RESPONSES TO NRC REQUESTS
DATED APRIL 22, 1977, FOR ADDITIONAL
INFORMATION REGARDING THE PROPOSED COOLING
SYSTEM DESIGN CHANGE

DOCKET NO. 50-410

NINE MILE POINT NUCLEAR STATION - UNIT 2
NIAGARA MOHAWK POWER CORPORATION

SEPTEMBER 30, 1977

FIGURE R4-2
 AVERAGE ANNUAL
 WATER DEPOSITION
 (LBS/ACRE/YR)
 NINE MILE POINT NUCLEAR STATION-UNIT 2
 NIAGARA MOHAWK POWER CORPORATION

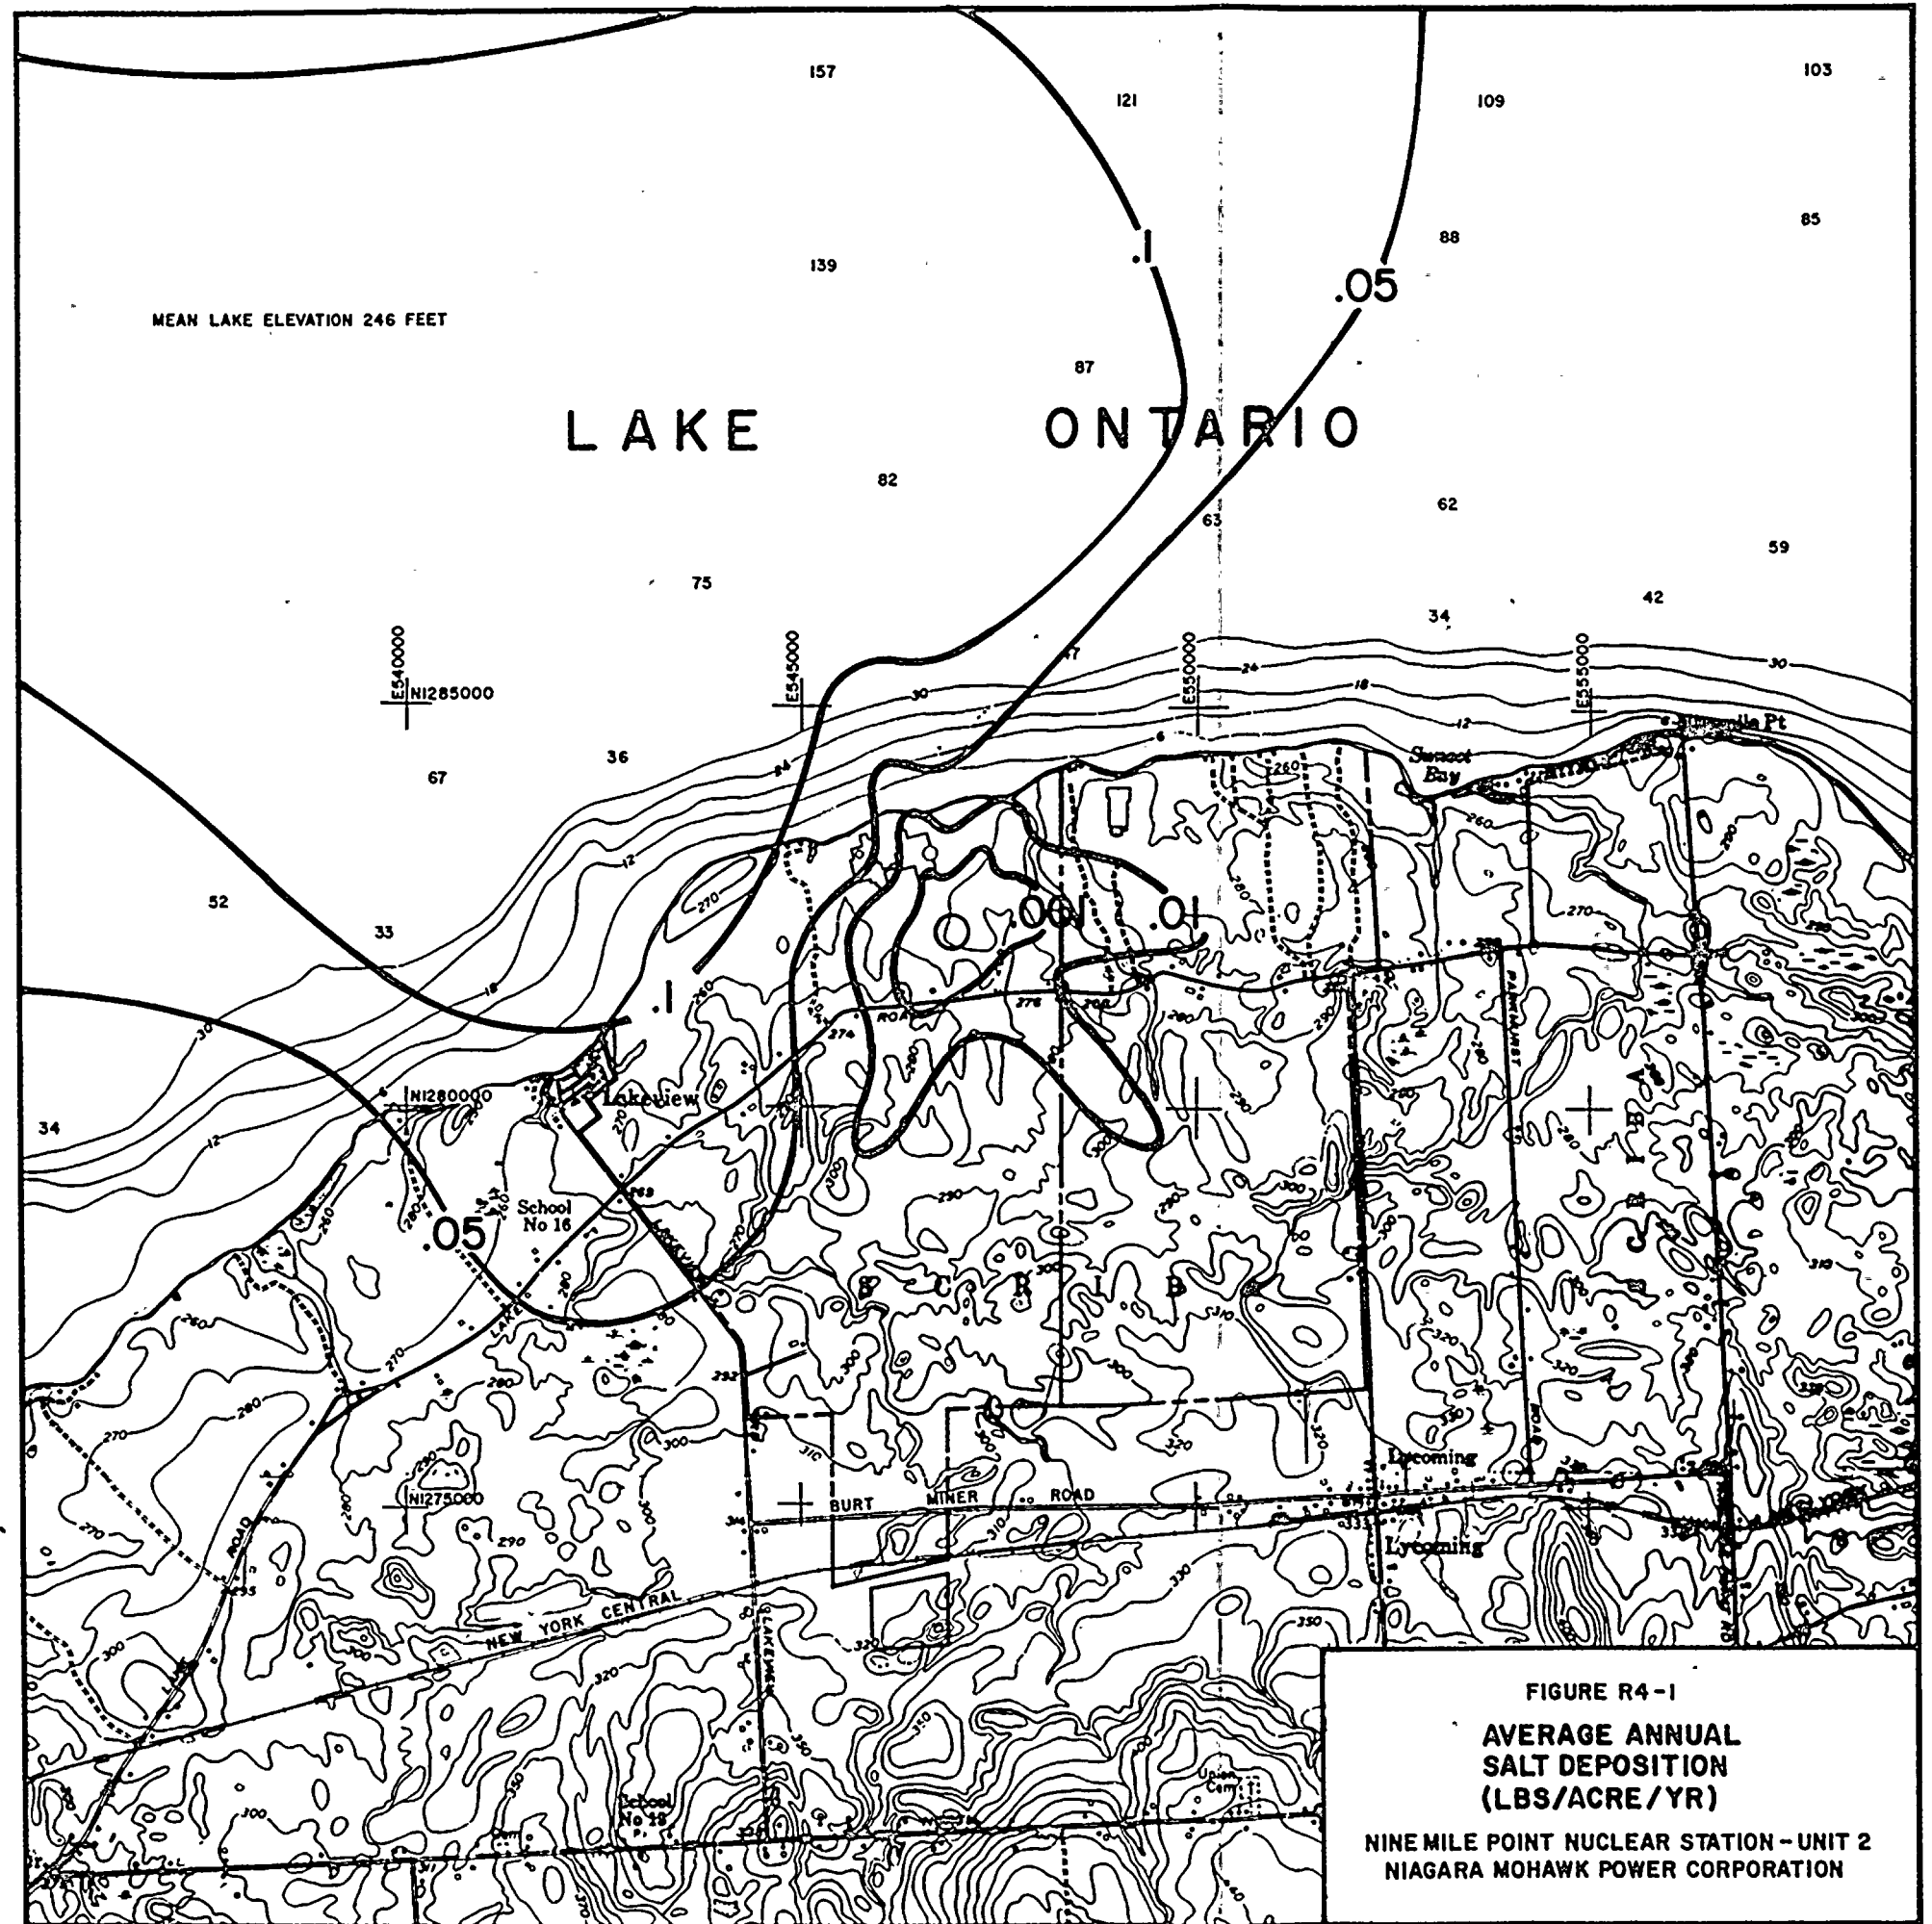
In addition to Figures 5 and 6, Water and Salt Drift for an Annual Period, provide figures showing water and salt drift amounts for each month or season of the year.

Average annual salt deposition rates in lbs/acre/year are shown in Figure 4-1. The maximum salt deposition rate was predicted to be 0.27 lbs/acre/year, 6750 feet northwest of the tower. Figure 4-2 presents annual water deposition rates in lbs/acre/year with maximum value of 690.6 lbs/acre/year occurring 6750 feet northwest of the tower. This amount of water corresponds to 0.0030 inches of water per year.
